# Access Compliance Report

## Public Rights-of-Way

Intersection ID: 9382	Main Street: RUPERT_LN	Cross Street: COVECREEK_DR	Location: SW
ADA ID: C4F4D8EEDDCB	Ramp Type: Perp	Initial Pass/Fail: Fail	Overall Compliance: No
Codes/Mitigation Info/Possible Solution		Field Measurements/Component Compliance	
Severity Score: 18.75

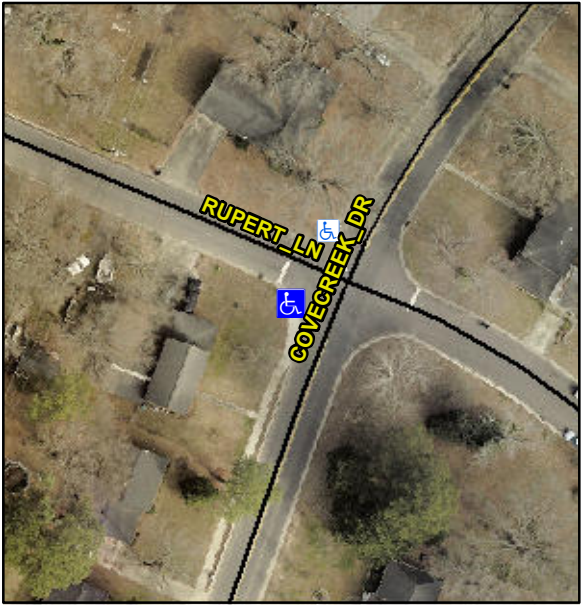
Possible Solutions:						
	Remove & Replace Entire Ramp.						
	Surveyor Notes:						
	N/A						
	PROW/ADA:						
	Not Found, R304.5.1, R304.5.3						
		Compliance	Description	Data	Compliance	Description	Data
		N/A	Ramp Length (in)	48.0	Yes	Ramp Slope (%)	5.8
		No	Ramp Width (in)	35.0	No	Ramp XSlope (%)	2.4
		N/A	Flare Type LT	N/A	N/A	Flare Type RT	N/A
<p>Street 1 Name</p> <p>Stop Condition-Street 2</p> <p>Street 2 Name</p> <p>Stop Condition-Street 1</p>		N/A	Flare Slope LT (%)	N/A	N/A	Flare Slope RT (%)	N/A
		N/A	Flare Traversable LT?	N/A	N/A	Flare Traversable RT?	N/A
		N/A	Landing Length (in)	N/A	N/A	DWS Provided?	N/A
		N/A	Landing Width (in)	N/A	N/A	DWS Contrast?	N/A
		N/A	Landing Slope (%)	N/A	N/A	DWS Length (in)	N/A
		N/A	Landing X Slope (%)	N/A	N/A	DWS Full Width?	N/A
		N/A	Landing Curb? (Y/N)	N/A	N/A	DWS Offset (in)	N/A
		N/A	Shared Landing?	N/A			
		N/A	Gutter Ponding?	N/A	N/A	Gutter Slope (%)	N/A
